FARR WEST CITY PLANNING COMMISSION AGENDA

August 10, 2023 at 6:00 p.m.
City Council Chambers
1896 North 1800 West
Farr West, UT 84404

MEMORANDUM

RE: **HART SUBDIVISION PHASE 4**
Final Plan Review

FARR WEST HART SUBDIVISION PHASE 4
LOCATED IN THE SOUTHWEST QUARTER OF SECTION 26,
TOWNSHIP 7 NORTH, RANGE 2 WEST, SALT LAKE BASE AND MERIDIAN,
FARR WEST CITY, WEBER COUNTY, UTAH
MARCH 2023

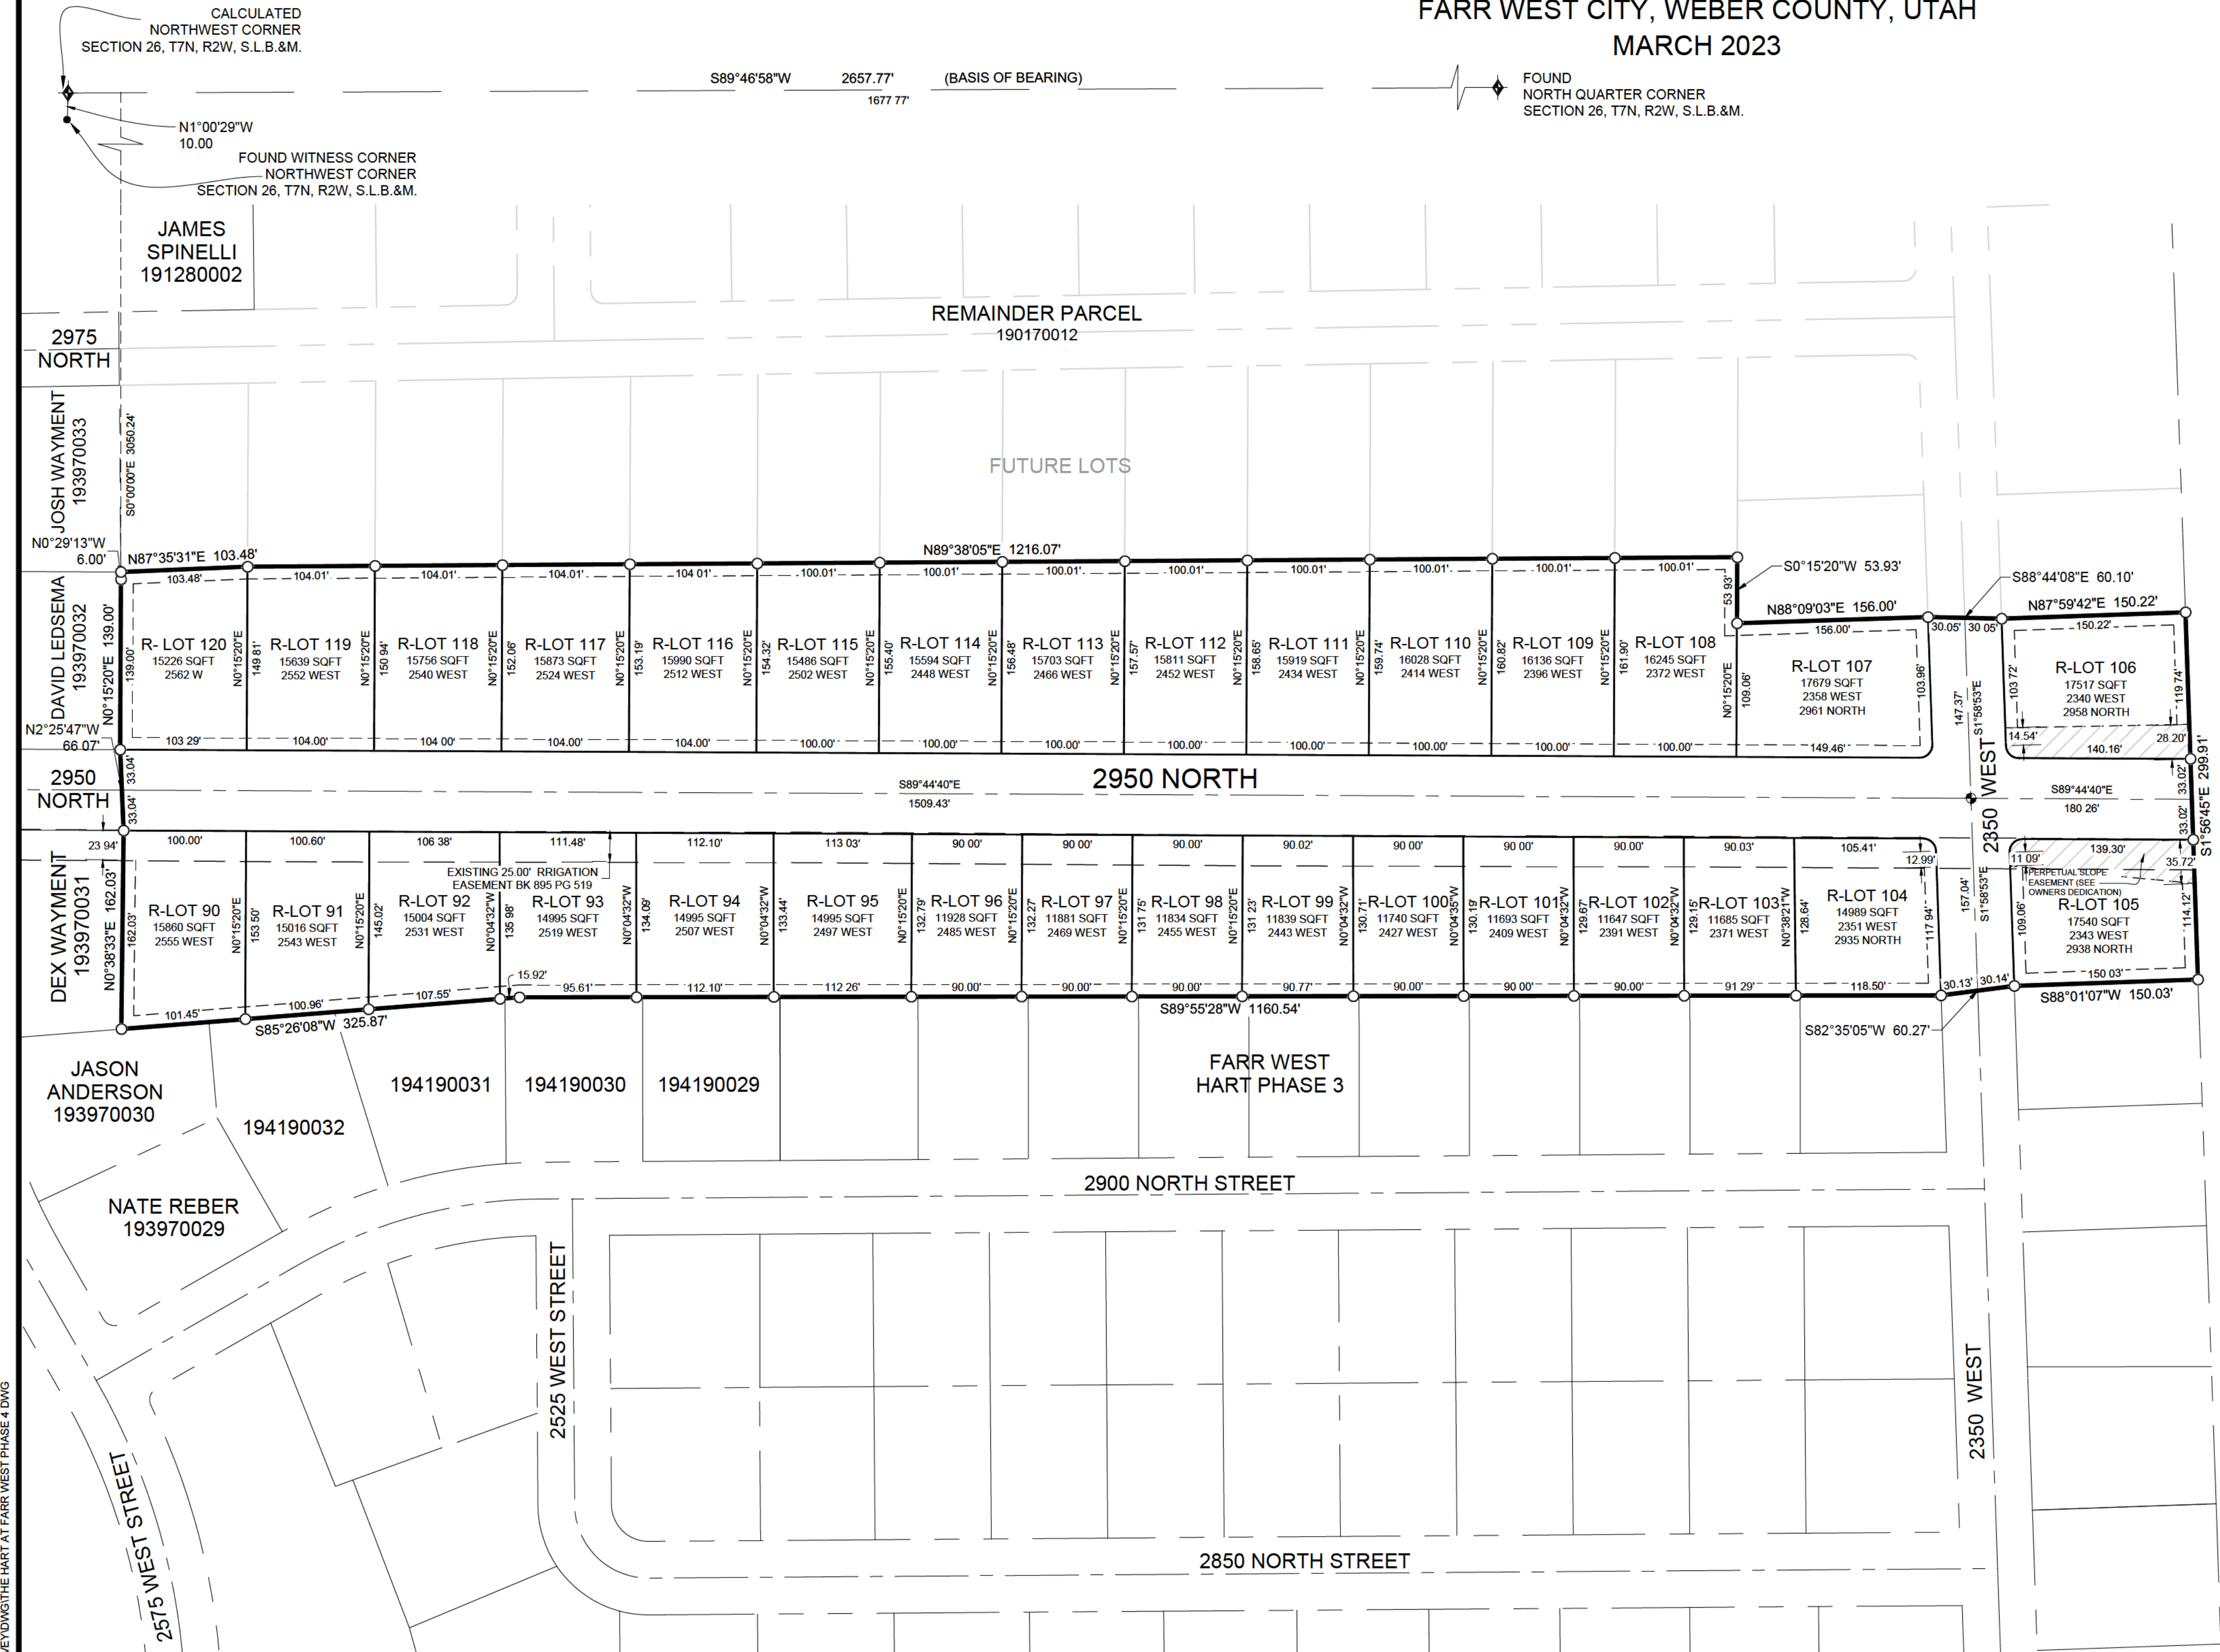
Our office has completed a review of the final plat and improvement drawings for the Hart Subdivision Phase 4 located at 2950 North 2350 West. Phase 4 of this development includes the development of 31 single family homes.

There is a Bureau of Reclamation (BOR) easement which runs down the south side of 2950 North and the Developer has now obtained all necessary approvals to cross that easement with the new utility services. Also, 2950 North is identified as a collector road which could potentially cross the Willard Canal in the future. The right-of-way for that future road going over the canal is being dedicated on this plat but the road will not be constructed at this point.

We recommend approval at this time with the following items to be completed before construction begins:

1. Complete a Storm Water Pollution Prevention Plan (SWPPP) and file a Notice of Intent (NOI) with the State before any construction begins.
2. An engineer's estimate for the cost of the public improvements will need to be submitted and approved by our office before the pre-construction meeting. This estimate will be the basis for the developer's agreement and the associated construction guarantee.
3. Prior to construction, the Developer and their Contractor must hold a pre-construction meeting with City staff to review construction requirements.
